## ADDENDUM NUMBER 2

February 27<sup>th</sup>, 2024

Project: Parker Engineering Project Number: PE23155  
Highway 25 Elevated Water Tank  
City of Millen  
EDA Investment No. 04-01-07759

500,000 GALLON ELEVATED  
WATER STORAGE TANK  
N.T.S.

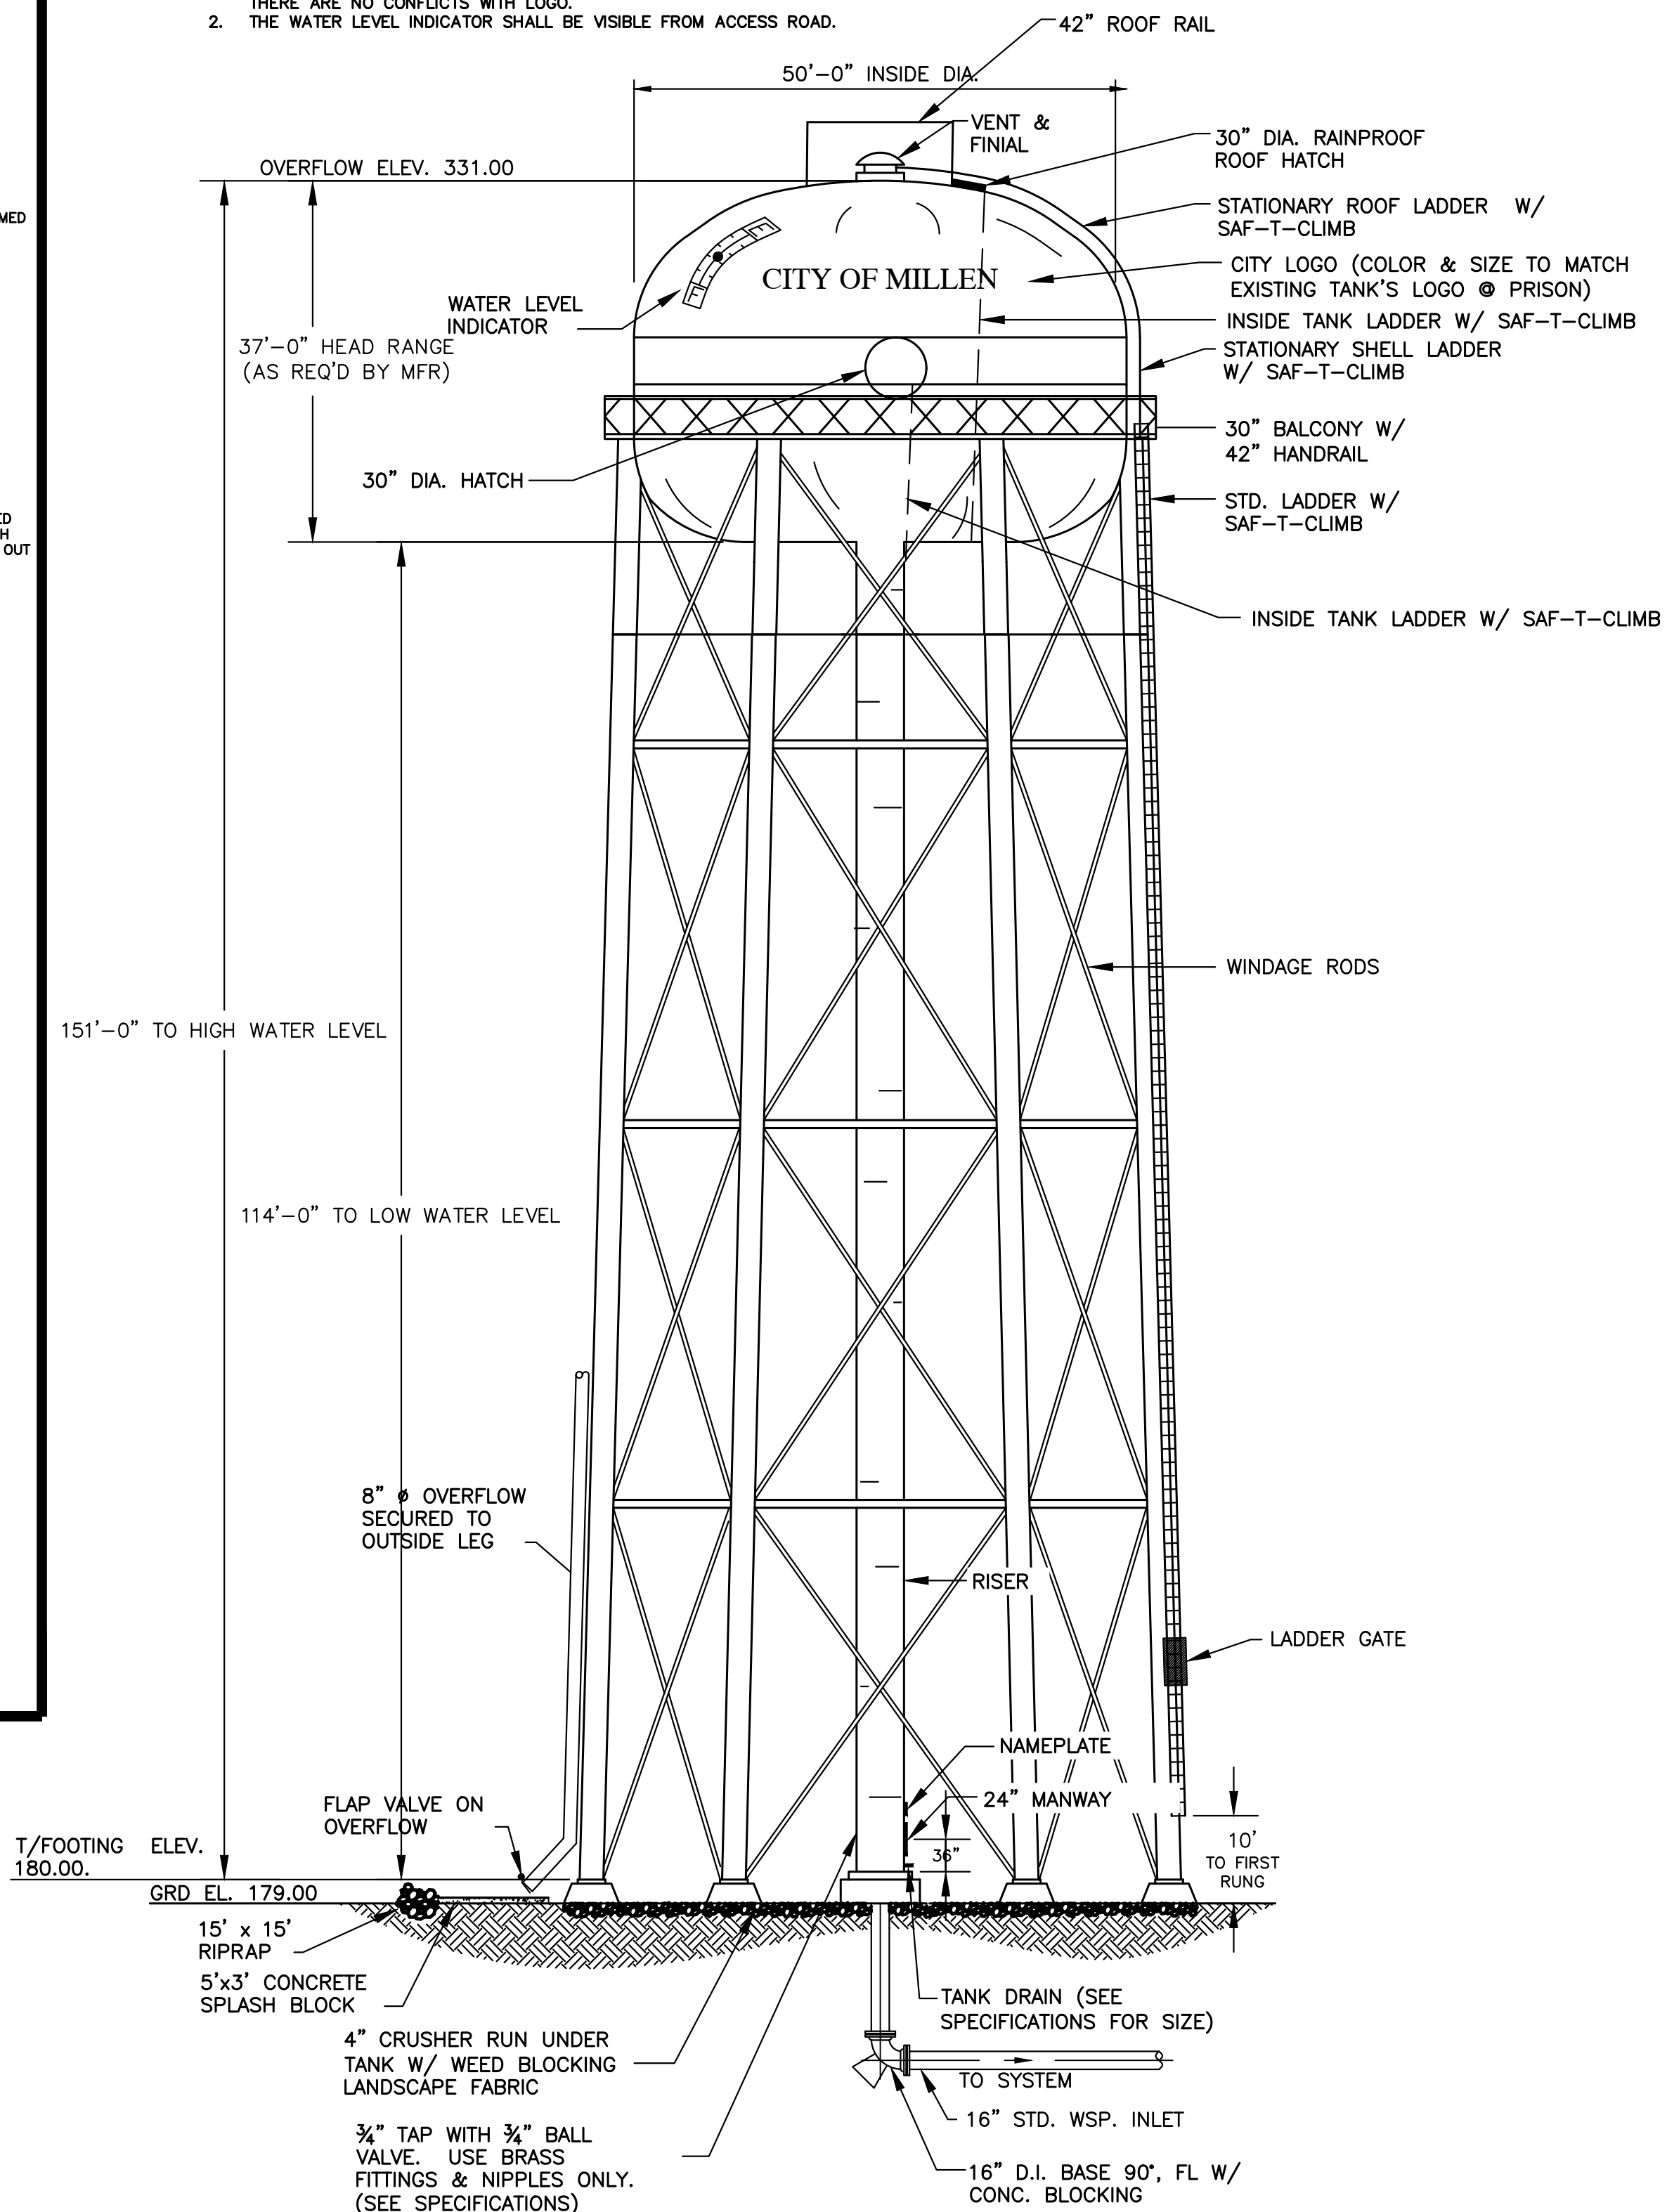
K. The height to HWL (146'-0") shown on Sheet T3 does not match the elevations specified in Section 15280 1.5.A (147' LWL). Please clarify the HWL elevation.

*Use HWL 151. Updated plans are provided. Plans were updated due to survey change.*
